**Hanlon-Deerfield Elementary
School Building Project**

School Building Committee
5 Aug 2021

Revised Floor Plan – Extended Learning Area: Shifted Science Space Cubbies Consolidated and Relocated

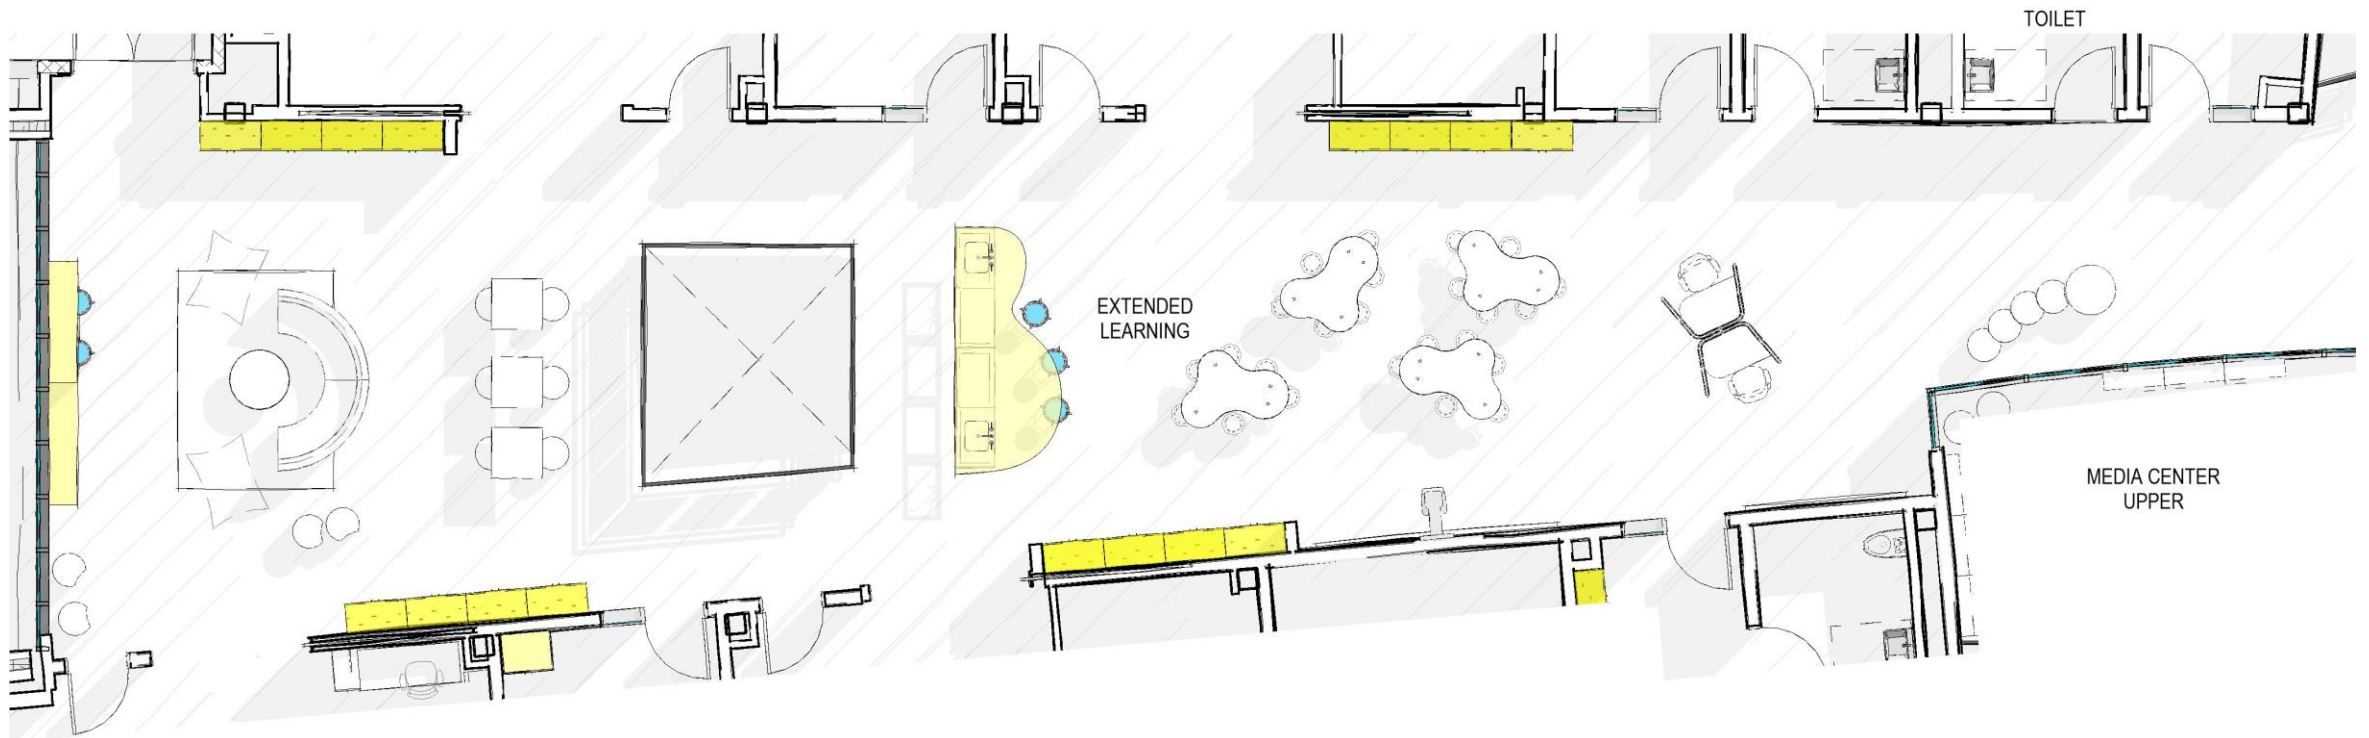
Upper Level – Southern Wing (4th and 5th grade) – proposed revisions with cubbies outboard and consolidated

Building Exterior Update

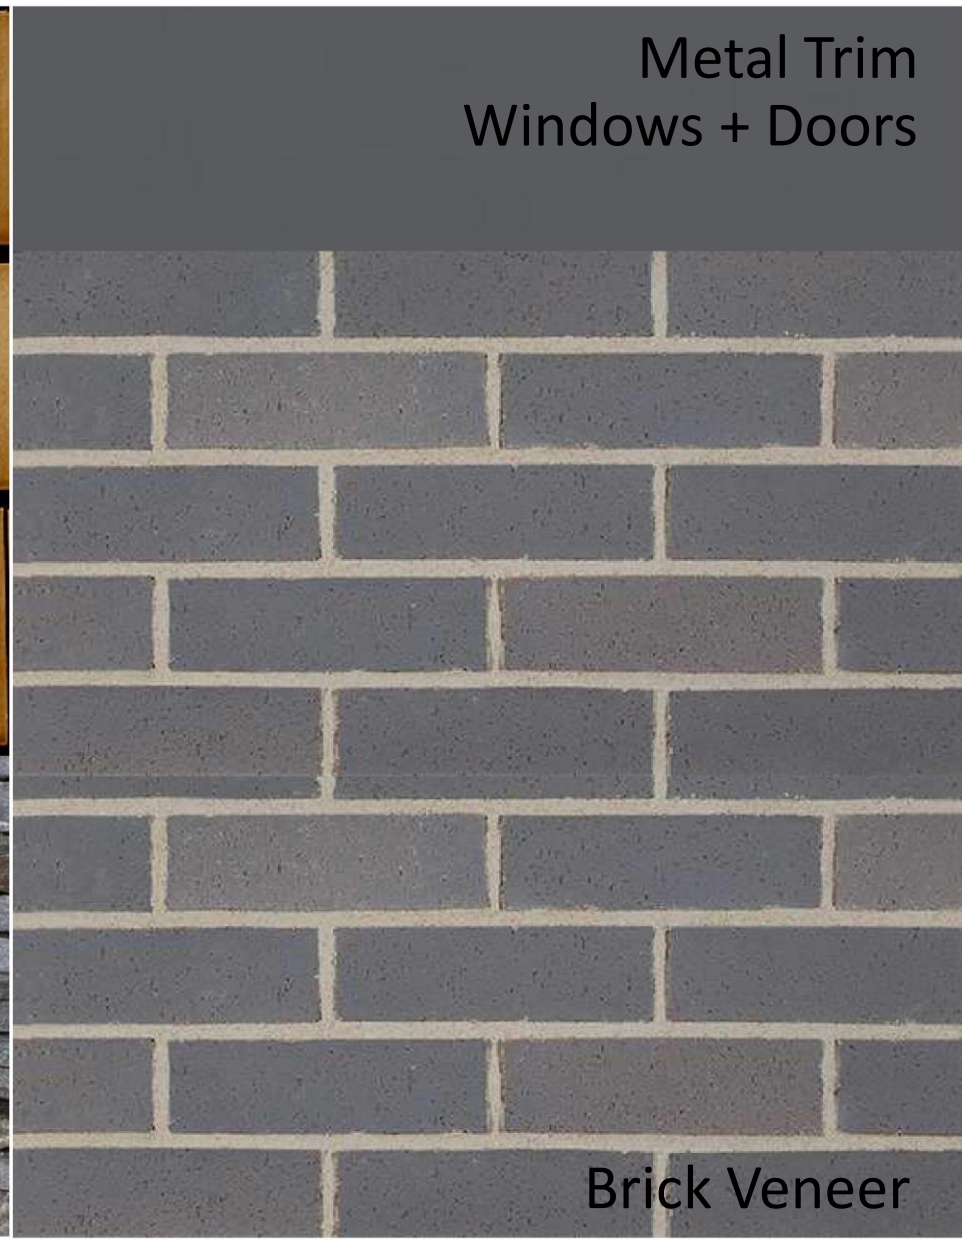
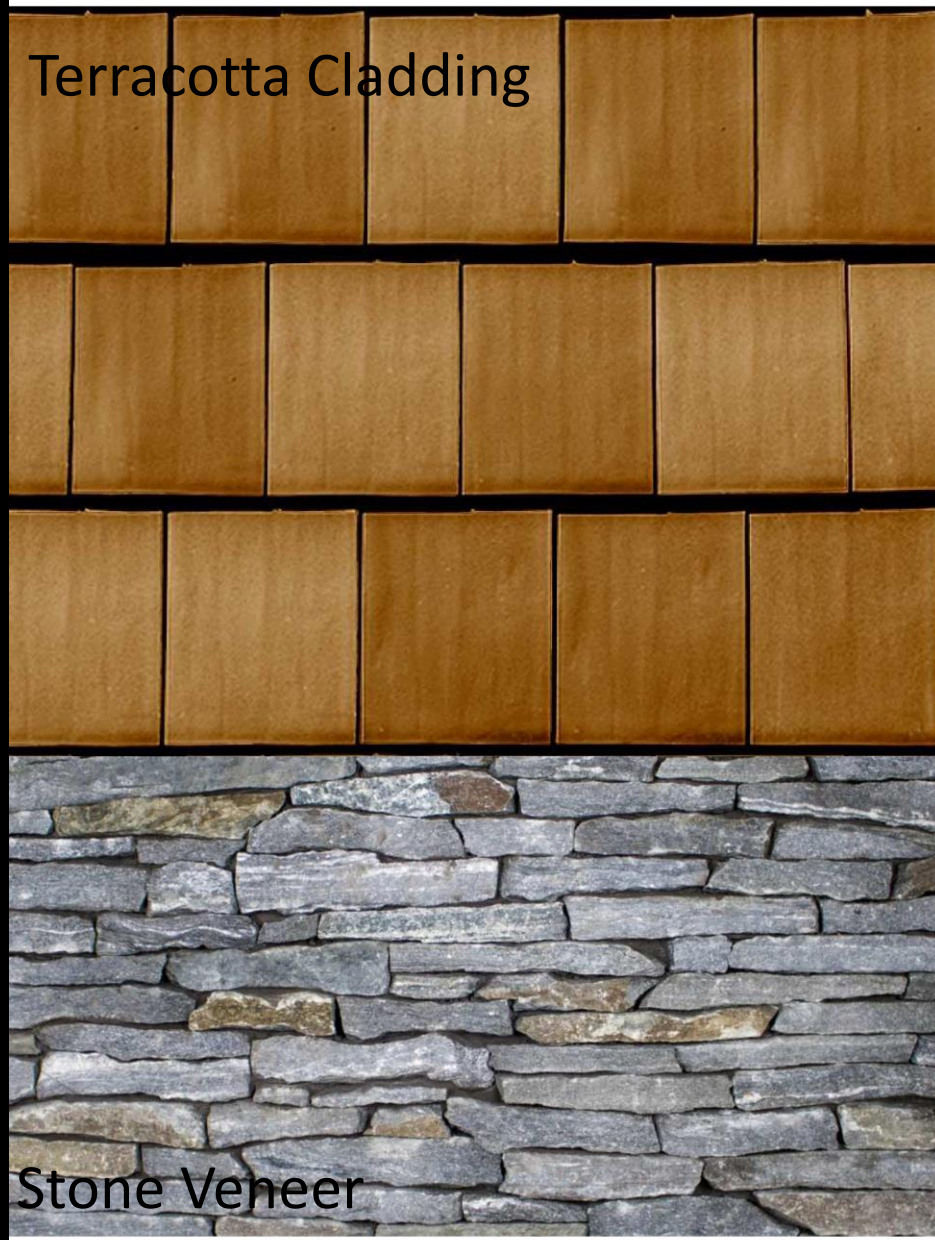
Roof Edges
Canopy
Windows

Playground Concept Review - Previous

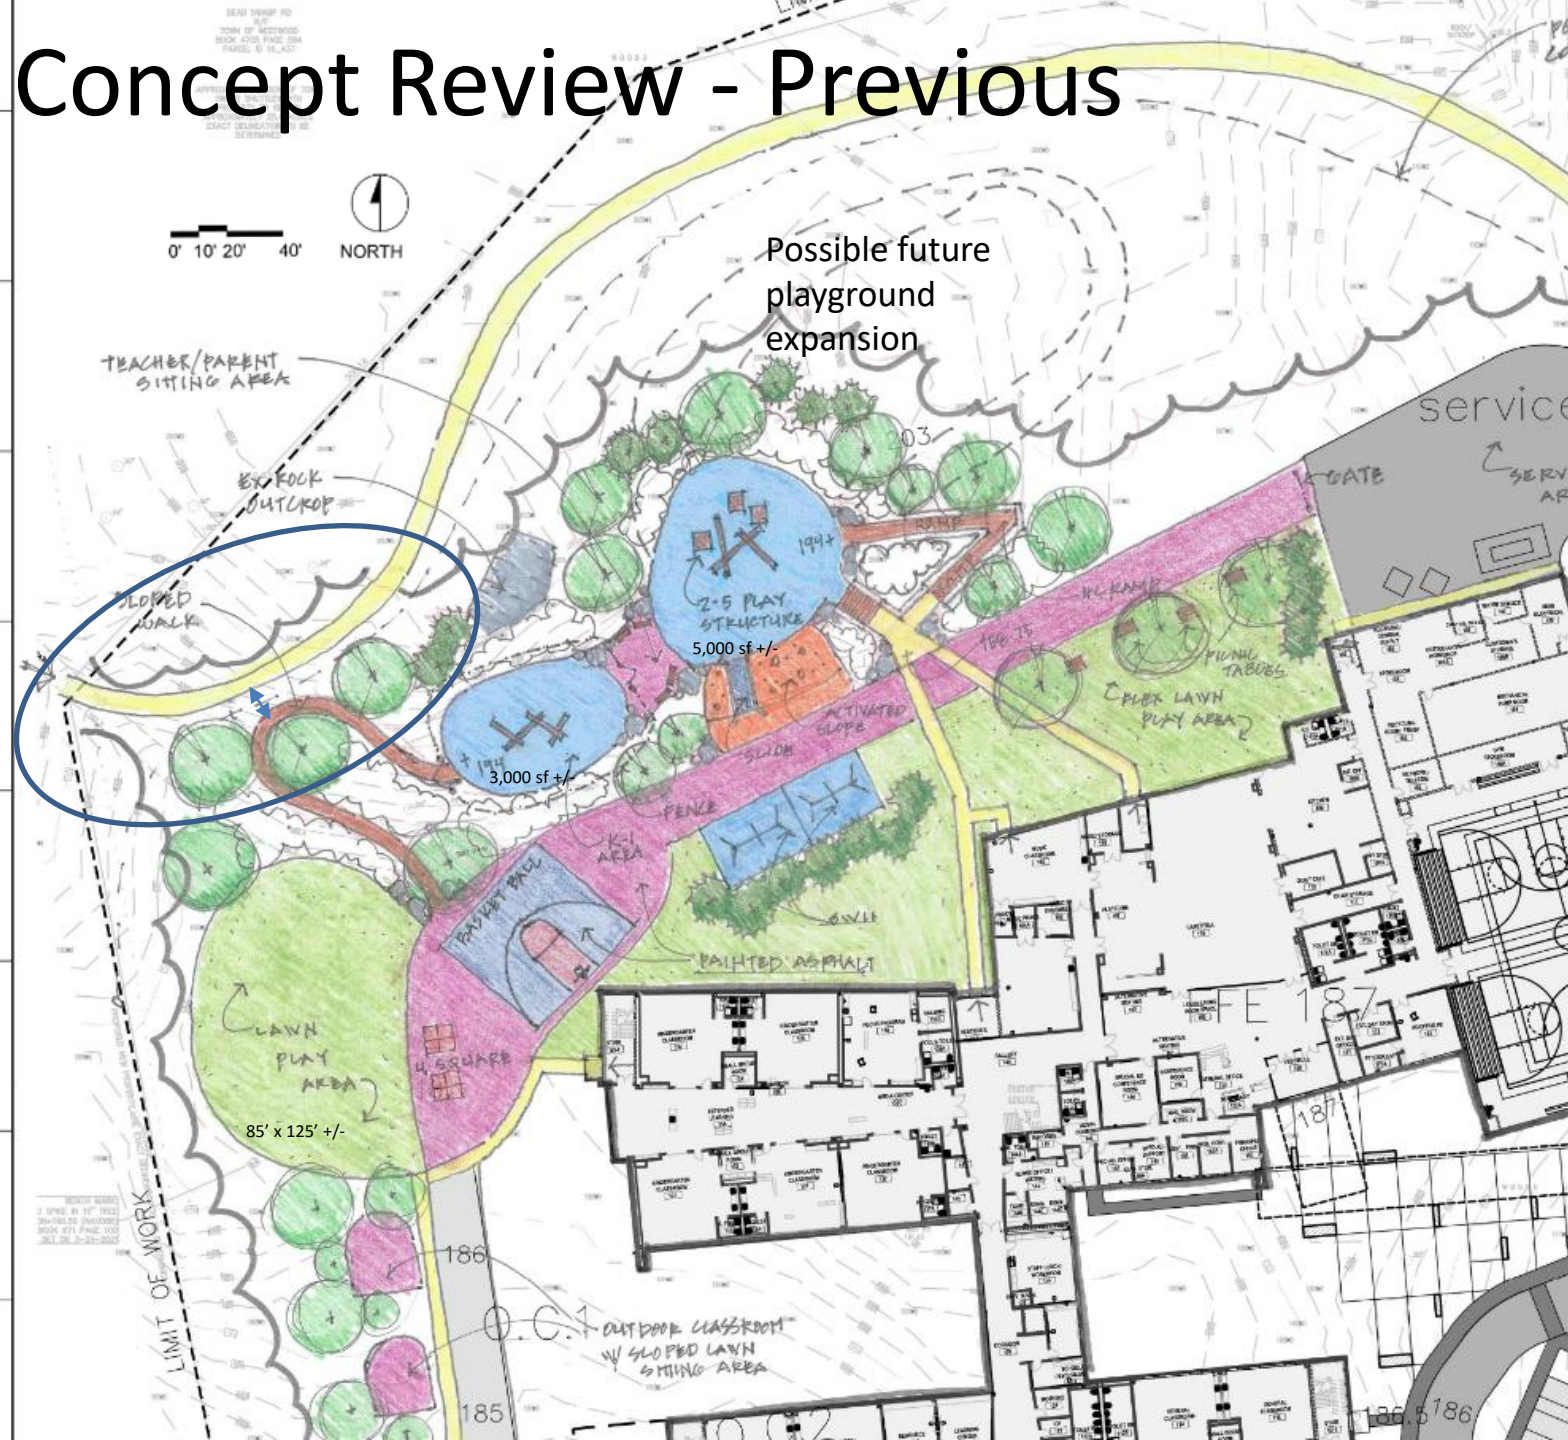
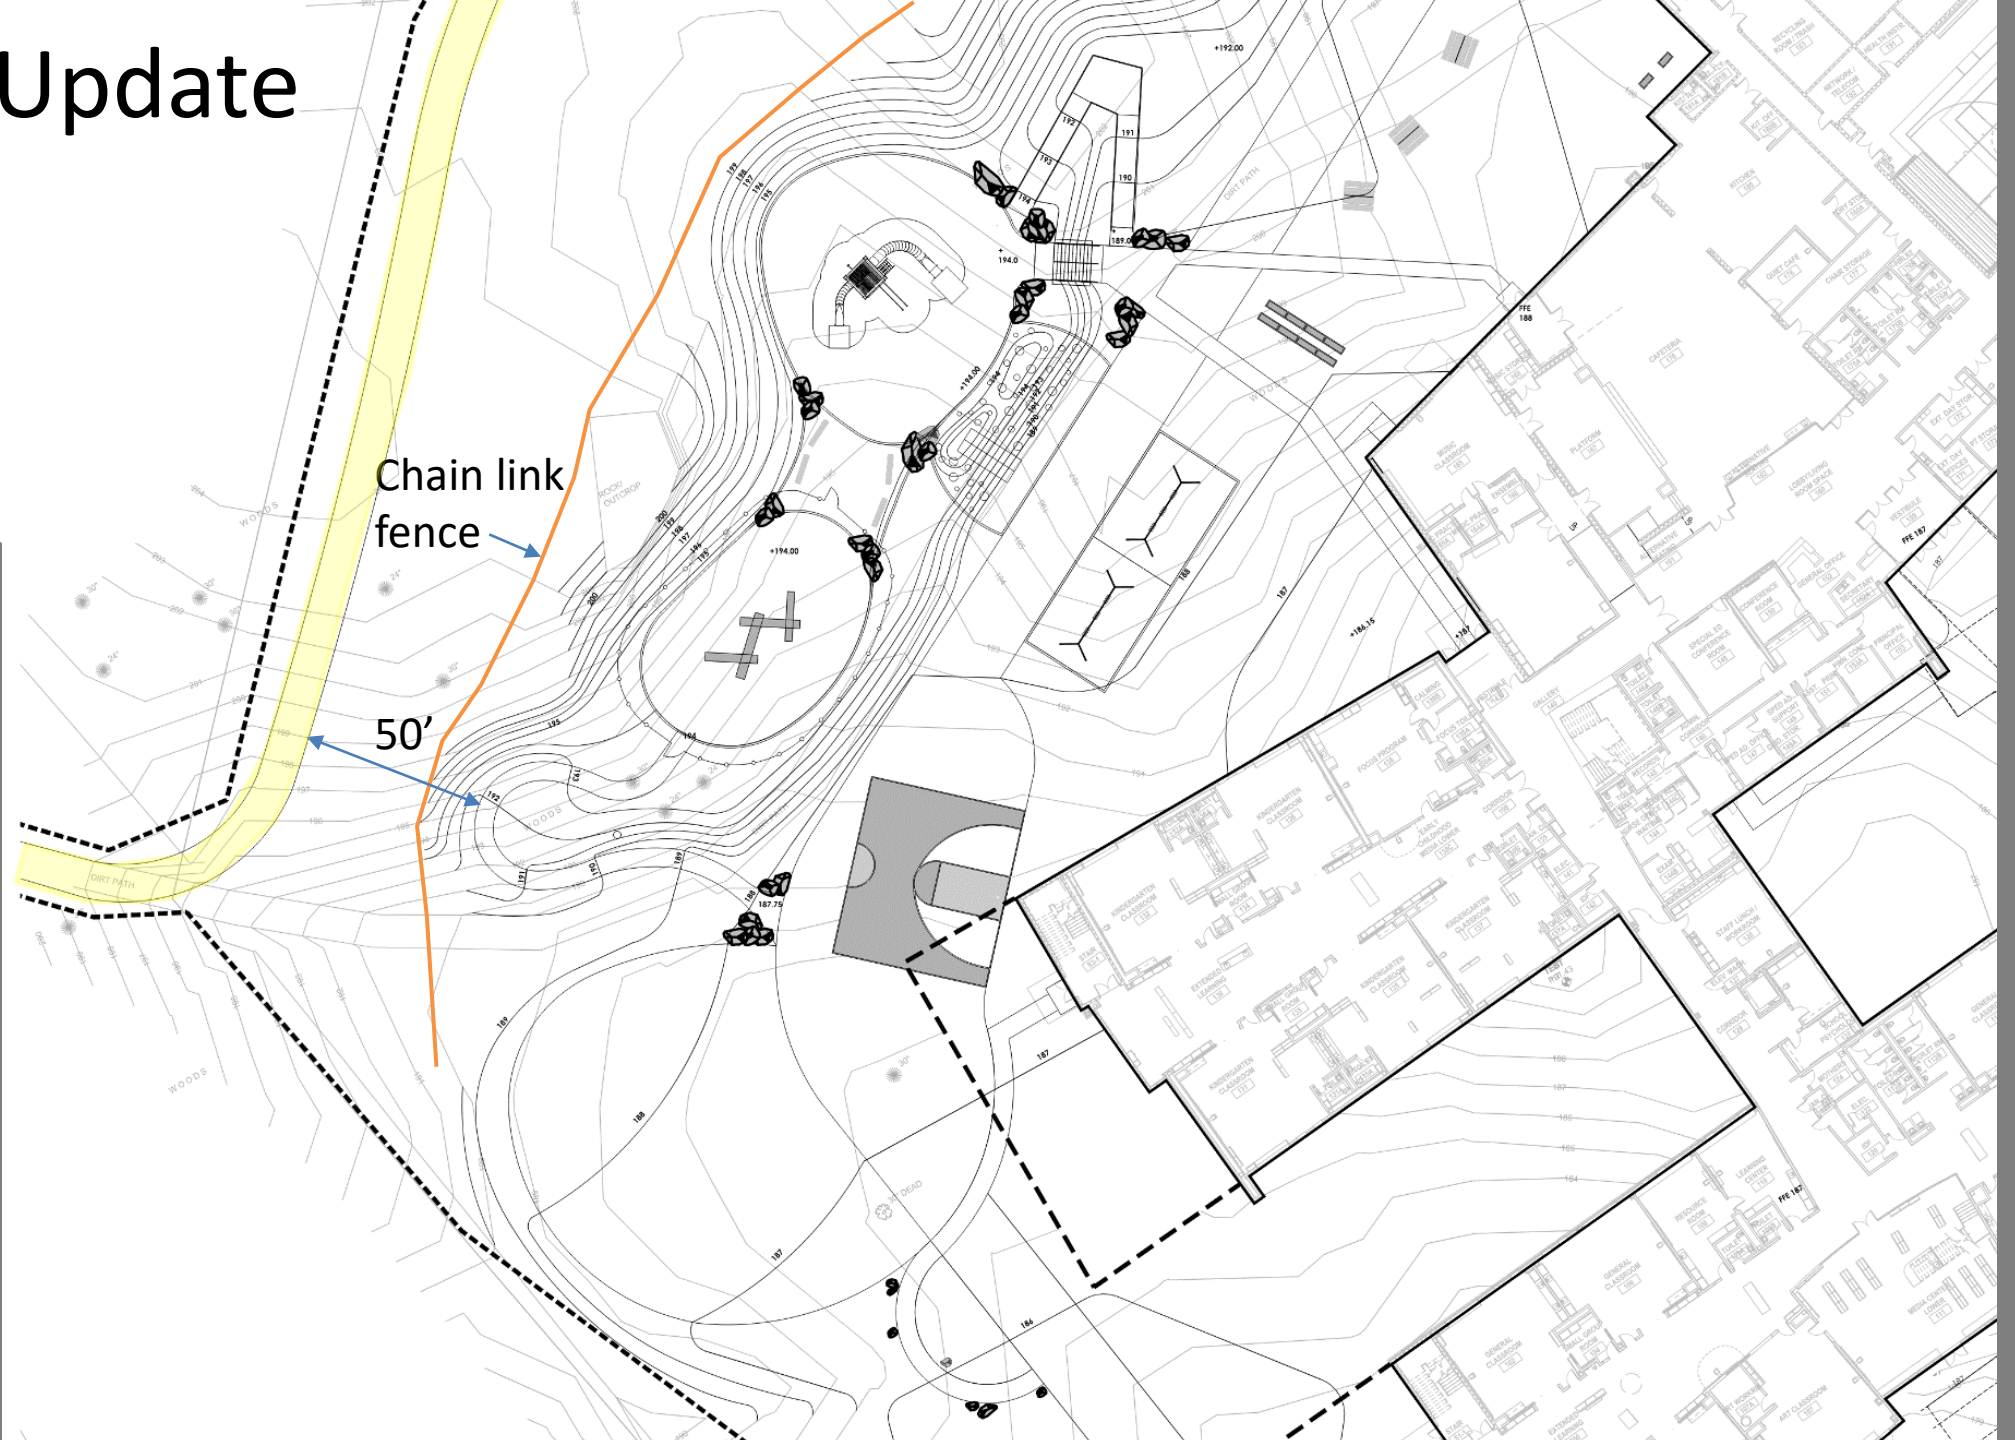
10' distance
between trail
and walking
path

50' distance to
access trail, and
chain link fence
along northern
edge of
playground
